## **PETITION EXHIBIT 11**

Re: 425 Tennant Ave, Morgan Hill, Santa Clara County; Cleanup Or  
Abatement Order No. R3-2006-0112, Which Amends Cleanup Or  
Abatement Order No. R3-2005-0014

Subject: Olin Response to Central Coast Water Board Comments  
SLIC: 425 Tennant Ave, Morgan Hill  
Second and Third Quarter 2006 Groundwater Monitoring Reports,  
and East of Site Characterization Report  
MACTEC Project No. 6100070002-09.07

**RE: REVIEW OF OLIN CORPORATION REPORTS: (1) LLAGAS SUBBASIN  
CLEANUP WORKPLAN, JUNE 15, 2007; (2) SECOND QUARTER 2007  
GROUNDWATER MONITORING REPORT, JULY 30, 2007**

Capture Area of Proposed Deep Aquifer Extraction Well  
Tennant Well On  
Response to Central Coast Water Board Comments  
Olin/Standard Fusee Site  
Morgan Hill, California

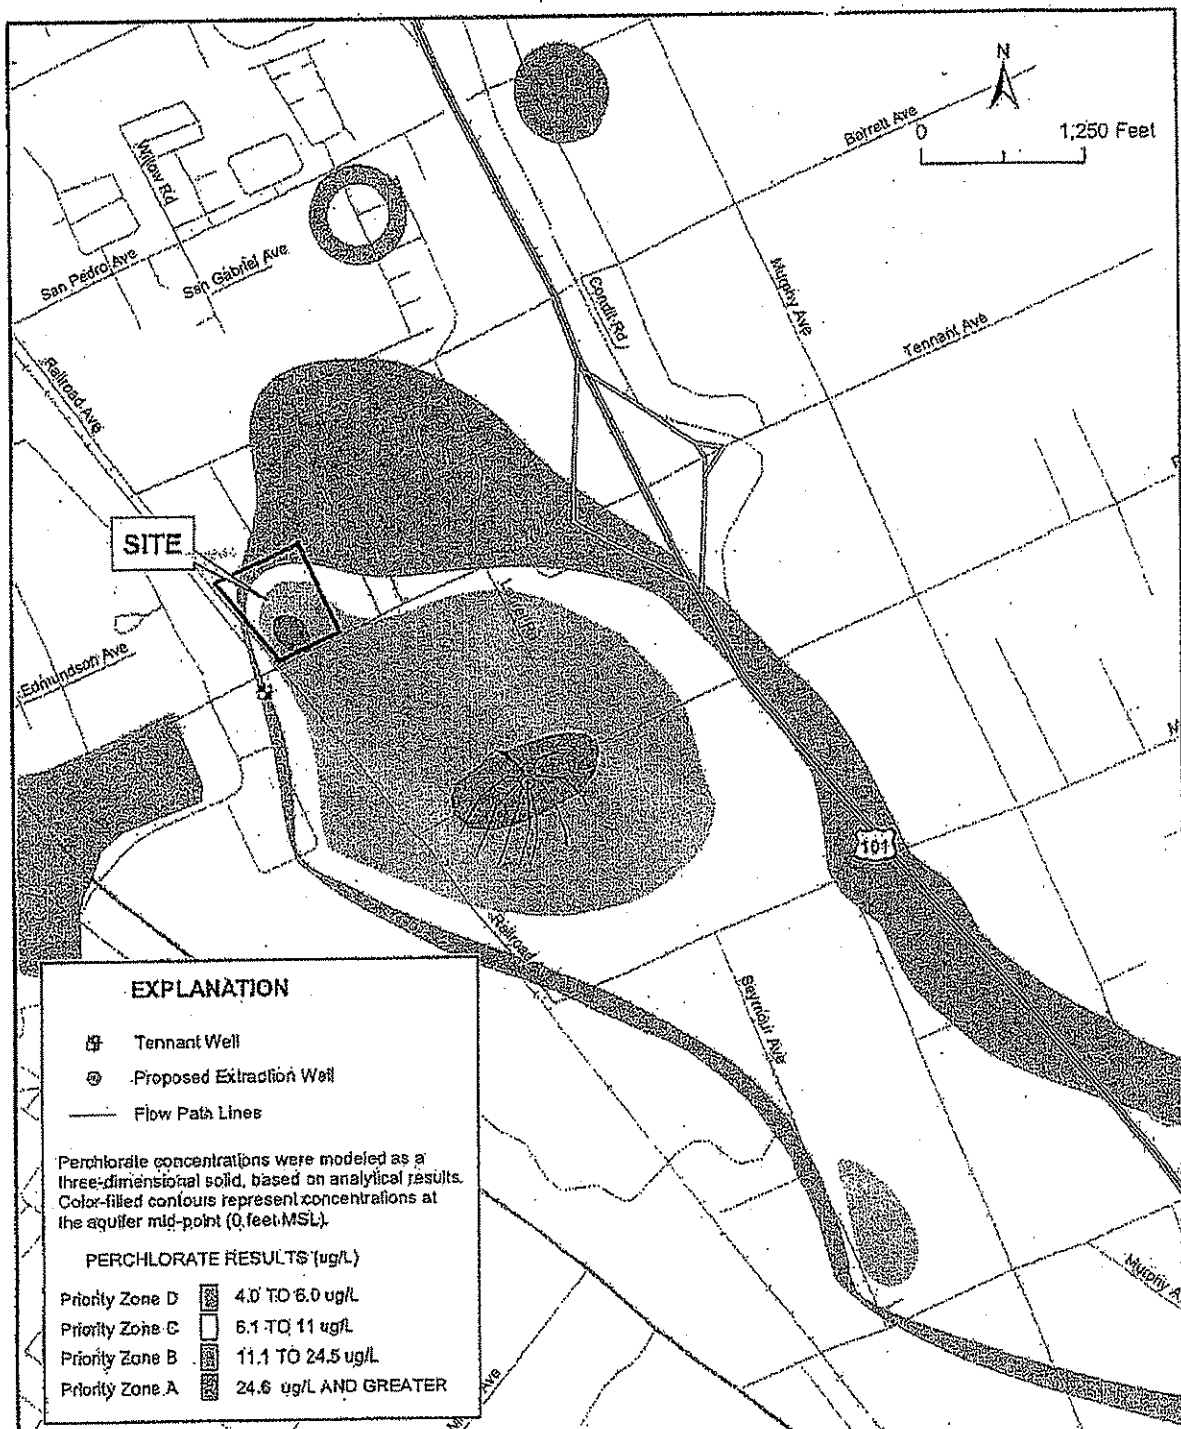
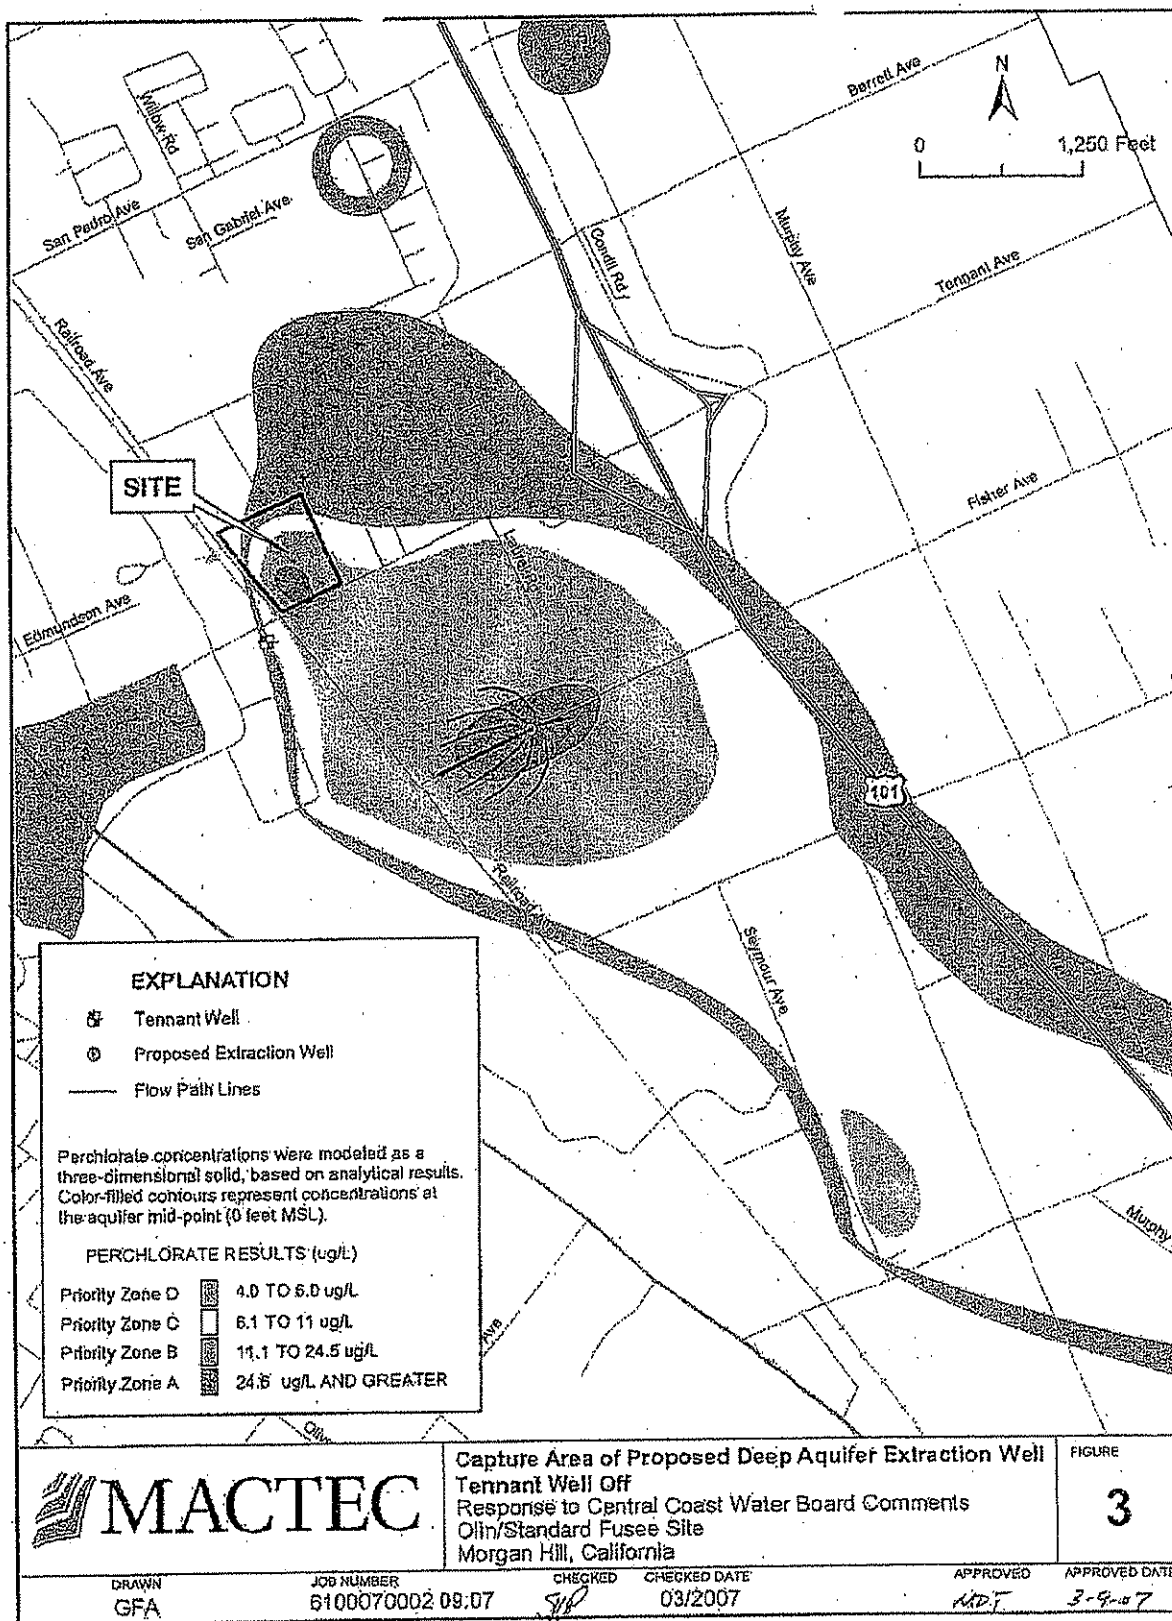
Comment 2. Provide an analysis of how the Tennant Well pumping affects perchlorate distribution and capture zones in the intermediate and deep aquifer zones. The analysis should evaluate if the Tennant Well is pulling the perchlorate plume downward, and to what extent the Tennant Well is providing hydraulic containment of the perchlorate plume in the intermediate and deep aquifer.

Response: In a letter dated May 13, 2003, Olin Corporation stated that operation of the Tennant Well should not resume because of concerns regarding the potential for downward migration of perchlorate into the deep aquifer. Despite these concerns, the City of Morgan Hill elected to resume pumping and perchlorate concentrations have and continue to increase at MW-04C and MW-05C.

As reported in the *Area I Plume Migration Control Feasibility Study* (GeoSyntec, 2007), one extraction well is proposed for deep aquifer hydraulic containment of perchlorate within Assessment Area I. The numerical simulations referenced in this report include continuous operation of the Tennant Well. At the request of the Water Board, the deep aquifer capture simulation was modified to illustrate the potential capture area of the proposed extraction well without the influence of pumping from the Tennant Well. Potential capture areas from the proposed extraction well with respect to the Tennant Well operation as both on and off are illustrated on Figures 2 and 3. As these figures illustrate, that very little change occurs in the capture area of the proposed deep extraction well whether the Tennant Well is on or off.

<b>Groundwater Flow Direction and Gradients</b> Middle Deep Aquifer (Second Quarter 2007) Second Quarter 2007 Groundwater Monitoring Report Olin/Standard Fusee Site Morgan Hill, California		FIGURE <h1>3.21</h1>
	DRAWN BY LNC	JOB NUMBER 6100070002 09.06	CHECKED 
APPROVED 		APPROVED DATE 7/07

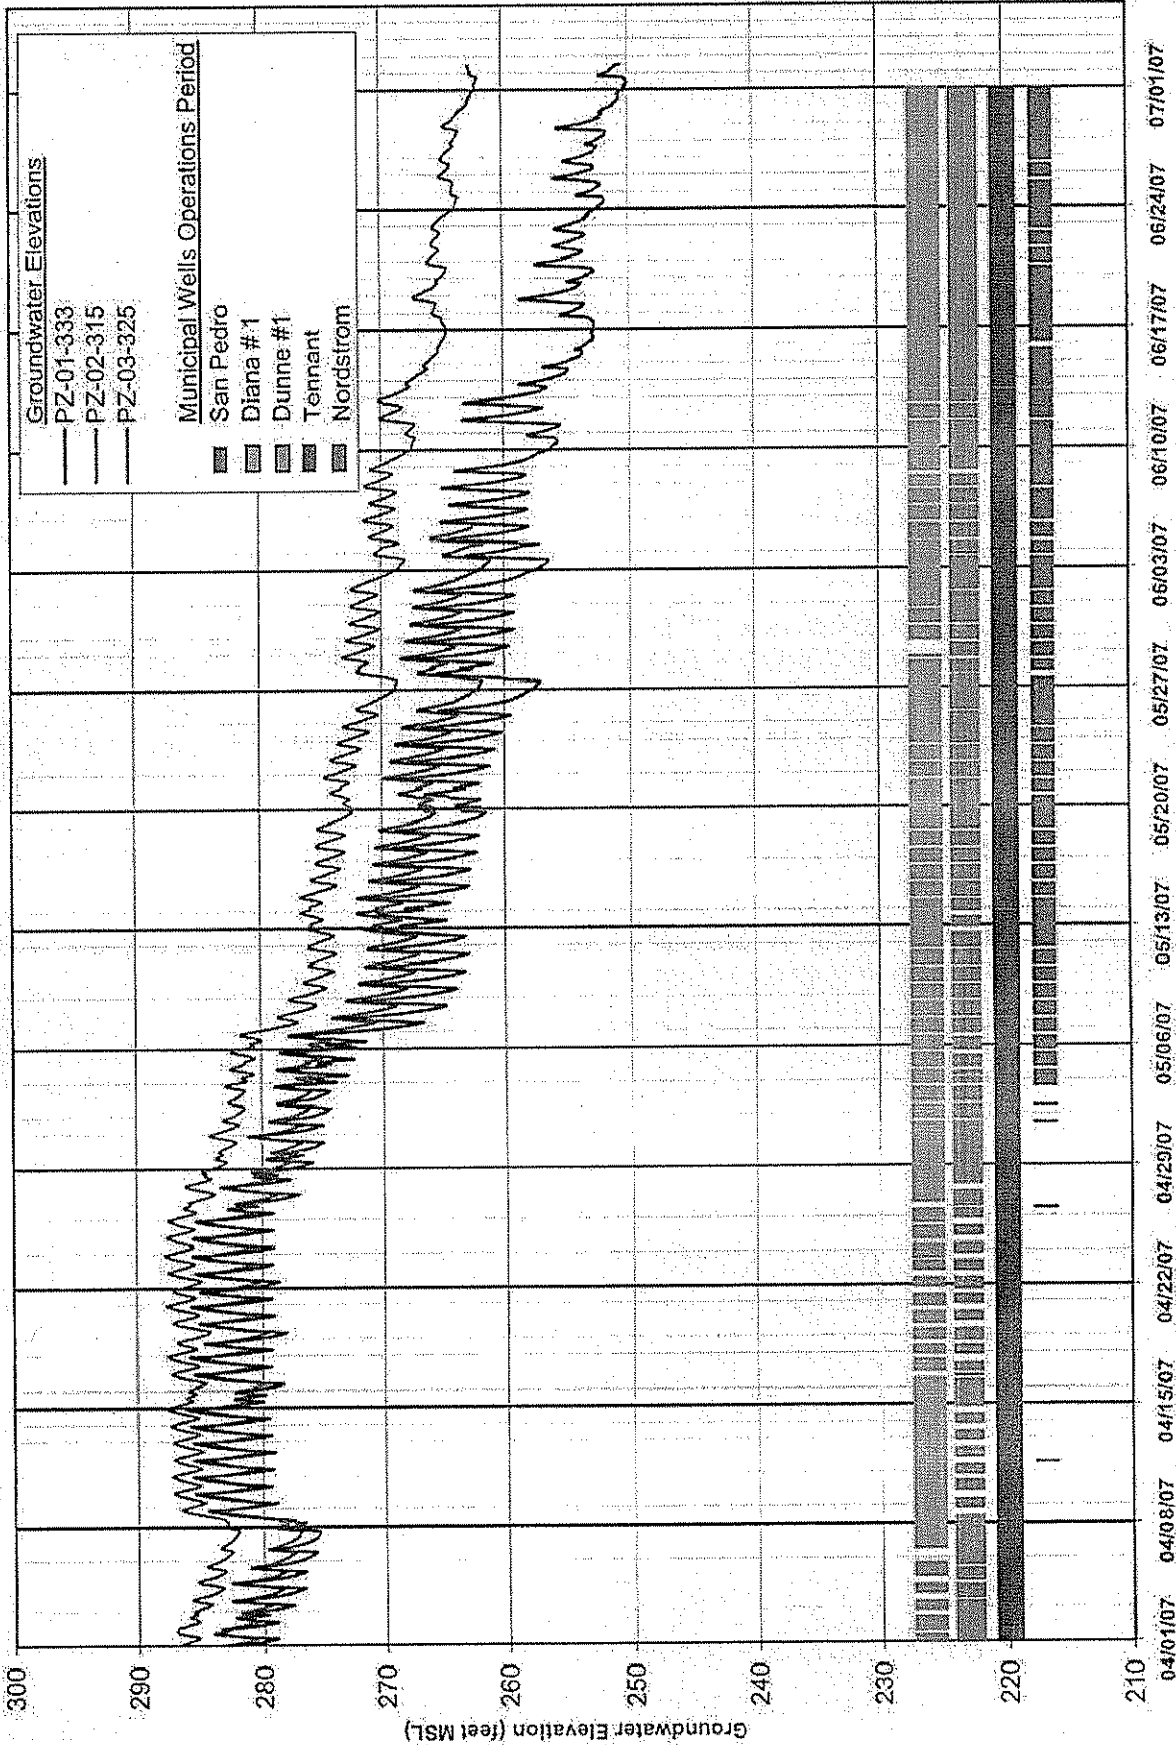
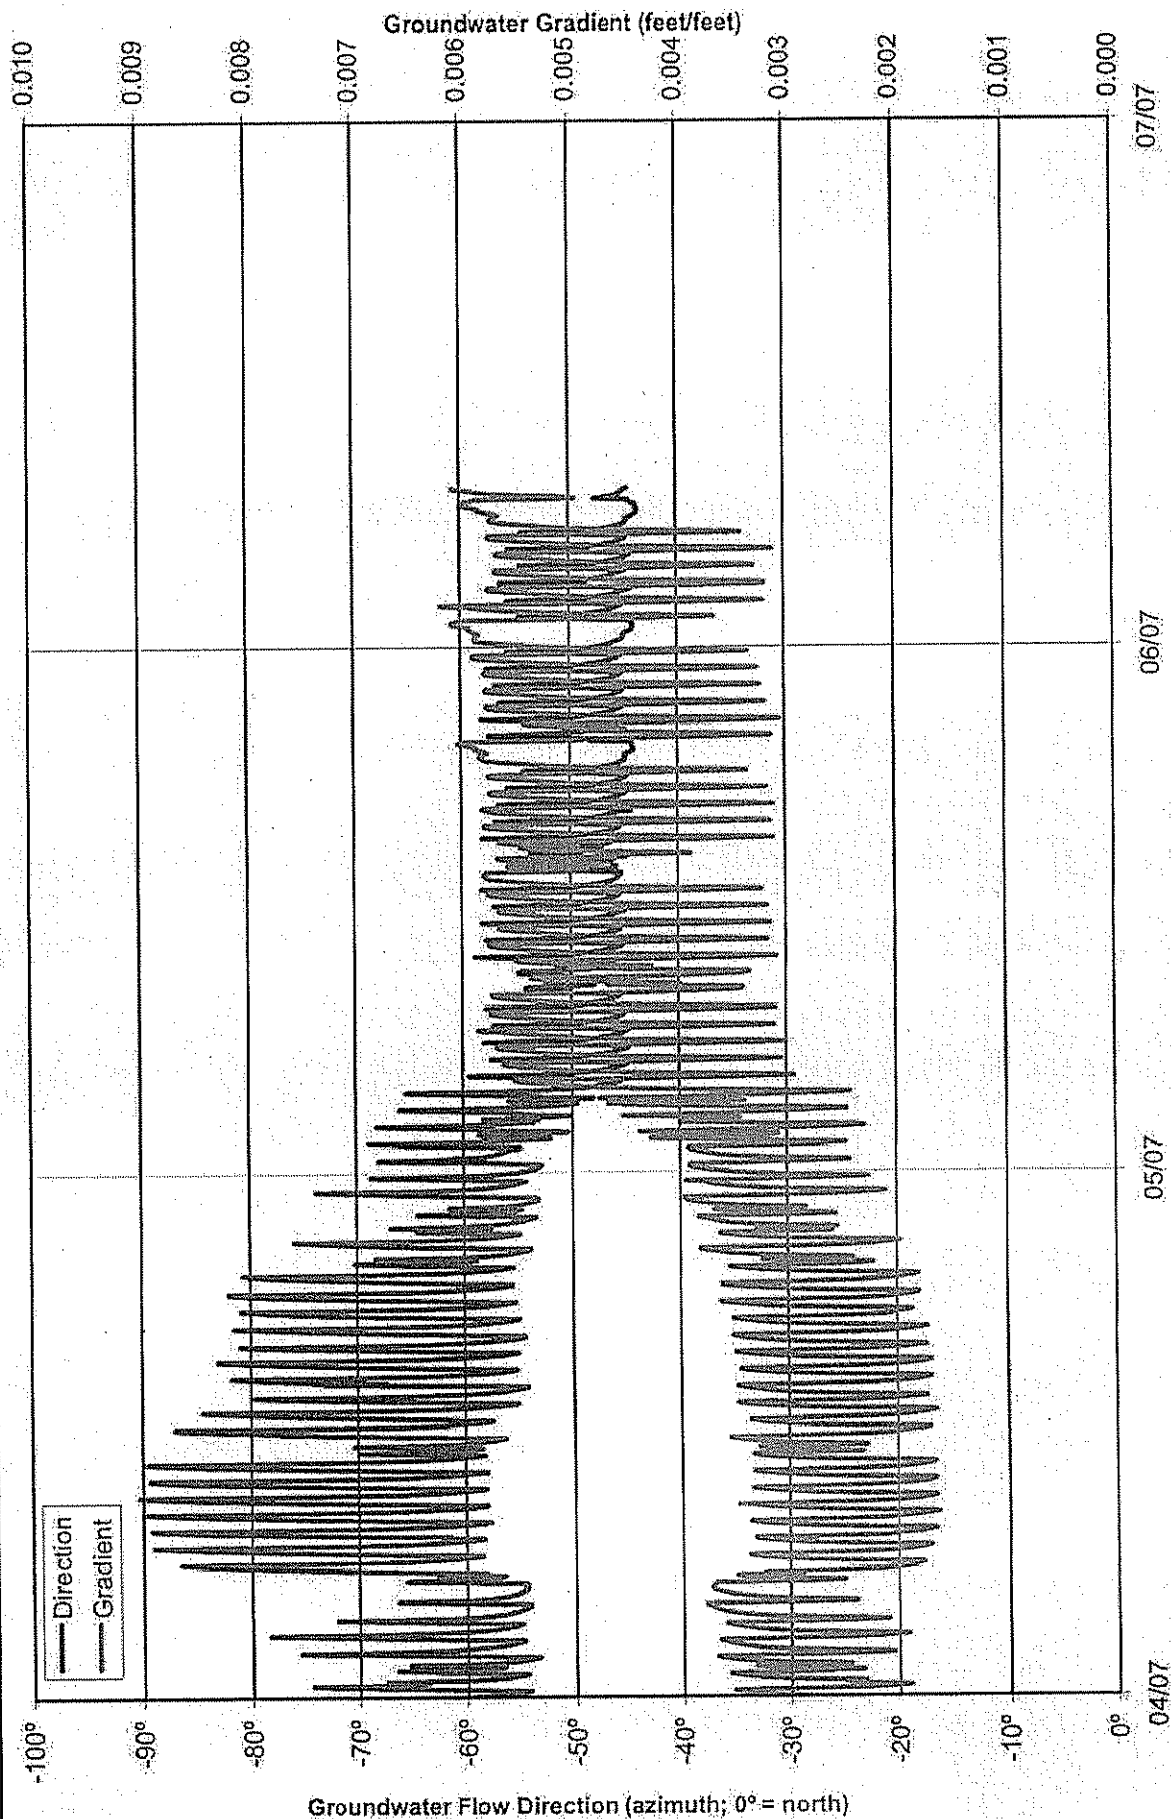
- a) As shown in Q2 Report Figure 3.21, groundwater flow directions between the triad of piezometers PZ-02-315, PZ-01-333 and PZ-03-325 through April 2007, with the Nordstrom well off-line, was northwestward (approximately N55°W) when City wells were pumping, and westward (N70°W to N90°W) when the wells were off, reflecting the typical daily pumping cycle of the City's wells. With the start-up of the Nordstrom Well in early May (approximately May 3) there was an immediate shift in groundwater flow direction of approximately 10 degrees to the north, resulting in a groundwater flow direction of N45°W, which was maintained for the duration of recorded data (to approximately June 19, 2007). As in the previous seven quarters (third quarter 2005 to first quarter 2007), there is no indication of a southerly component to groundwater flow in the Middle Deep Aquifer zone represented by this triad of piezometers.
